Make	Model	Year	Install	ECU	Lights	Locks	Trunk/Hatch	I/O Changes
DL-TL6 Lexus	GS 350 PTS AT	2016-20	Type 2	1/DKP	Park / Auto Yes	Mod/DDM	Yellow (8)	Green White/Blue X

FTI-TLP4: Installation and Configuration Notes

Overview: Mis-Wired door lock connector, field repair required.

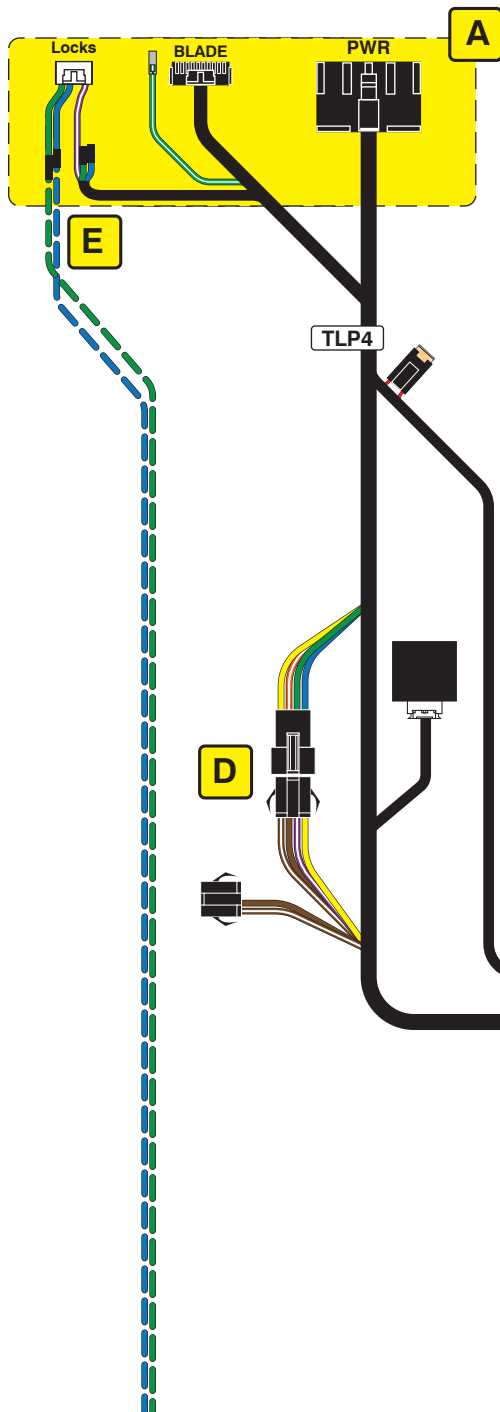
Issue: A review of the latest samples of **FTI-TLP4 T-harnesses** has revealed a misplaced trunk output wire in the 6-pin Lock Accessory Connector requiring that the wire be relocated to the correct position, to ensure safe operation when used. **Using the harness without addressing the issue will result in failed trunk/hatch control, and possible damage to the vehicle BCM.**

Correction: The harness purple/white wire in the latest production run of FTI-TLP4 harnesses has been inserted in the position normally used for the +12V power connection in the accessory harness. Before completing the installation, the installer must relocate the harness purple/white wire to the correct position, 1 space inward on the 6-pin connector, see illustrations below in Fig. 2.

To relocate the terminal, using a fine pick or Olfa type knife, depress the terminal locking barb and pull the purple/white wire from the connector housing. Once the terminal has been removed from the housing, again using the pick or knife, lift the locking barb about 1/16" (1.5 mm) and reinsert the terminal in the correct position. If upon initial examination of the harness the lock accessory connector looks like the illustration in Fig. 2, no modification is necessary, the wire is in the proper position.
